# HISTORIC AND DESIGN REVIEW COMMISSION

**HDRC CASE NO:** 2020-121  
**ADDRESS:** 1947 N NEW BRAUNFELS AVE  
**LEGAL DESCRIPTION:** NCB 1258 BLK 8 LOT E 55.85FT OF 1 THRU 5  
**ZONING:** C-2 IDZ, H  
**CITY COUNCIL DIST.:** 2  
**DISTRICT:** Government Hill Historic District  
**APPLICANT:** Edward Sherfey/NB GRAYSON LLC  
**OWNER:** NB GRAYSON LLC  
**TYPE OF WORK:** Replace the existing storefront door  
**APPLICATION RECEIVED:** March 06, 2020  
**60-DAY REVIEW:** May 06, 2020  
**CASE MANAGER:** Edward Hall

The applicant is requesting a Certificate of Appropriateness for approval to replace the existing, aluminum storefront entry doors with new aluminum doors.

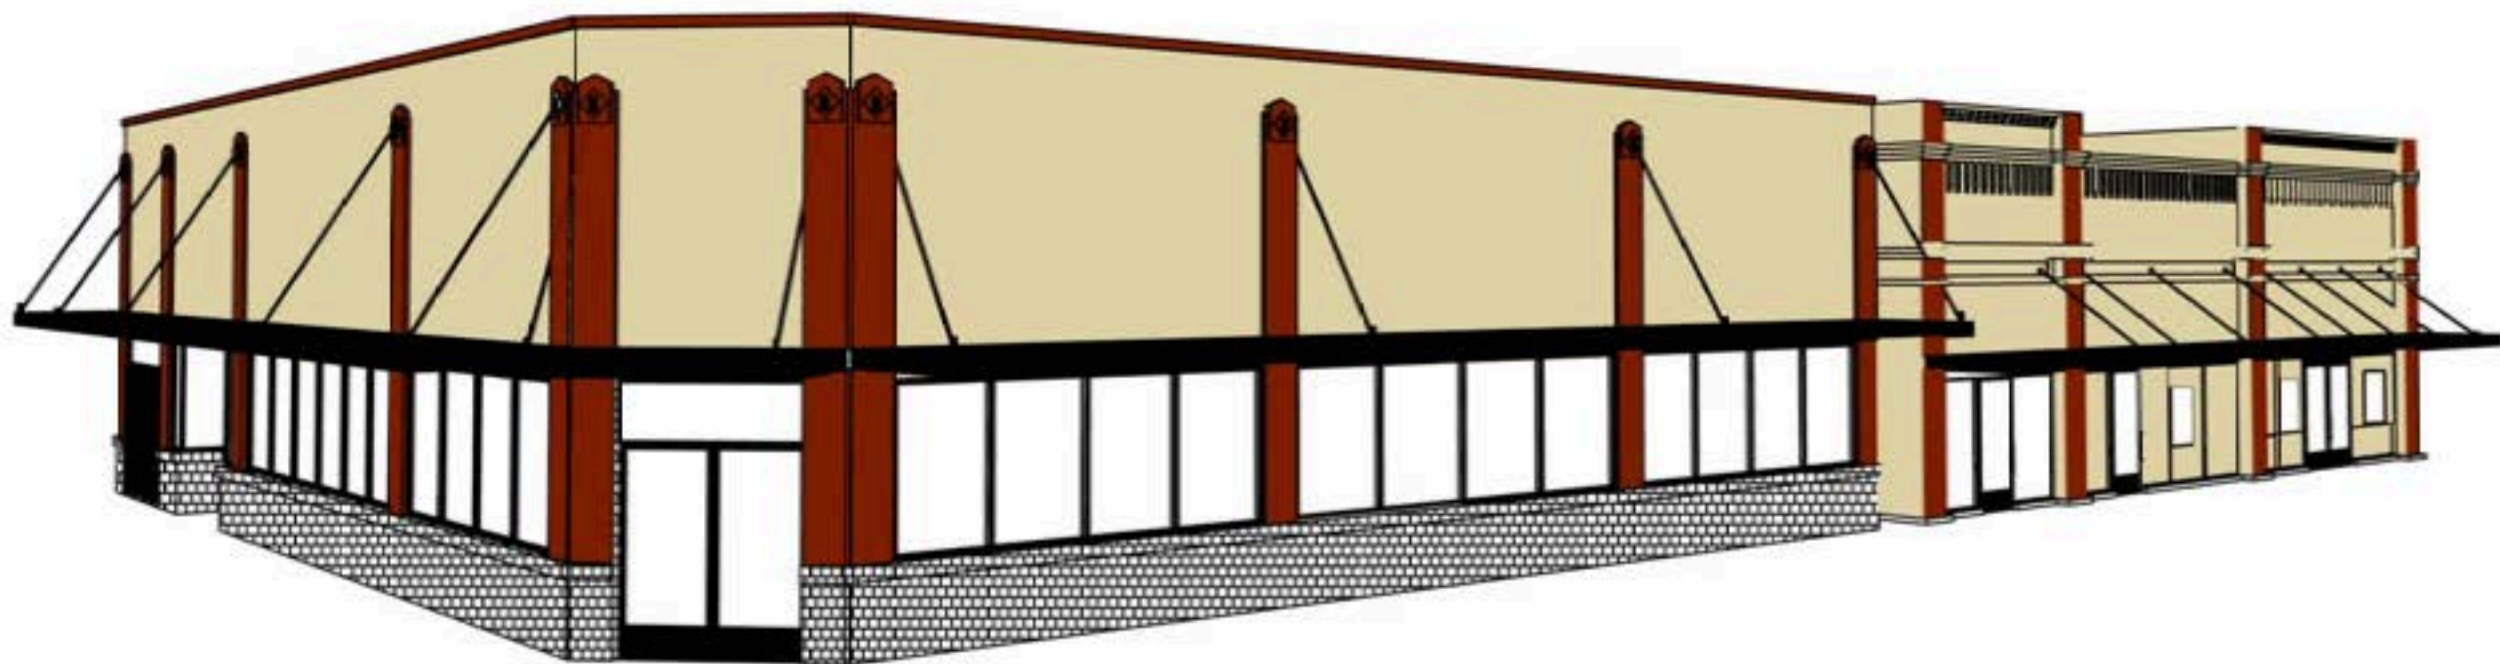
- a. The applicant is requesting a Certificate of Appropriateness for approval to replace the existing, aluminum storefront entry doors with new aluminum doors. The applicant has noted that the proposed profile (two doors beneath a transom window) will be maintained. This historic structure no longer features historic storefront elements, such as windows or doors.
- b. DOOR REPLACEMENT – The Guidelines for Exterior Maintenance and Alterations 10.B.i. notes that façade elements that alter or destroy the historic building character of a historic structure should not be introduced. Generally, staff finds that the proposed replacement doors will not destroy the structure’s historic building pattern, as the applicant has noted that both the door and transom profiles will remain as the currently exist.

Staff recommends approval based on findings a and b.
